UNITED STATES  
DEPARTMENT OF THE INTERIOR  
BUREAU OF LAND MANAGEMENTFORM APPROVED  
OMB NO. 1004-0137  
Expires: January 31, 2018**SUNDRY NOTICES AND REPORTS ON WELLS**  
*Do not use this form for proposals to drill or to re-enter an abandoned well. Use form 3160-3 (APD) for such proposals.***SUBMIT IN TRIPLICATE - Other instructions on page 2**

5. Lease Serial No.  
NMNM77064
6. If Indian, Allottee or Tribe Name
7. If Unit or CA/Agreement, Name and/or No.
8. Well Name and No.  
MESA VERDE 6 FD 08
9. API Well No.  
30-025-32614-00-S1
10. Field and Pool or Exploratory Area  
MESA VERDE  
MESA VERDE-DELAWARE
11. County or Parish, State  
LEA COUNTY, NM

**\*\* BLM REVISED \*\* BLM REVISED \*\* BLM REVISED \*\* BLM REVISED \*\* BLM REVISED \*\***

PROPOSED WELLBORE

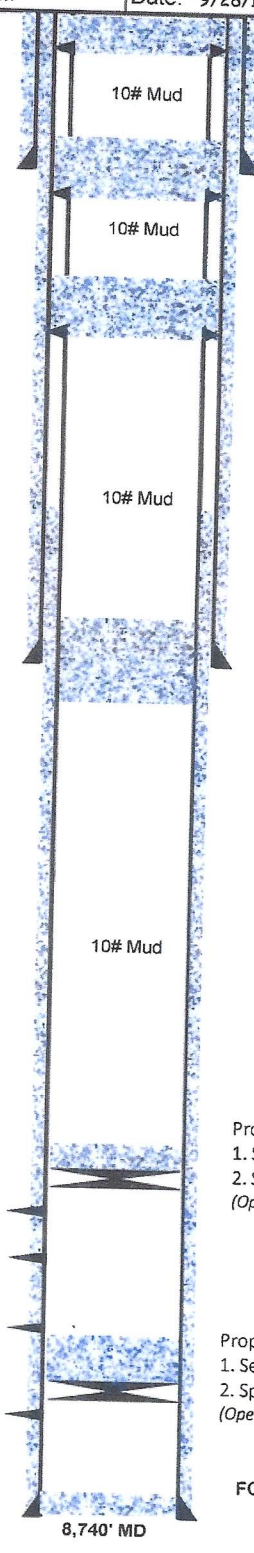
Verify @ surface (In/out)

1190' - 1078'

(In/out)

1140'

Leak test CIBP
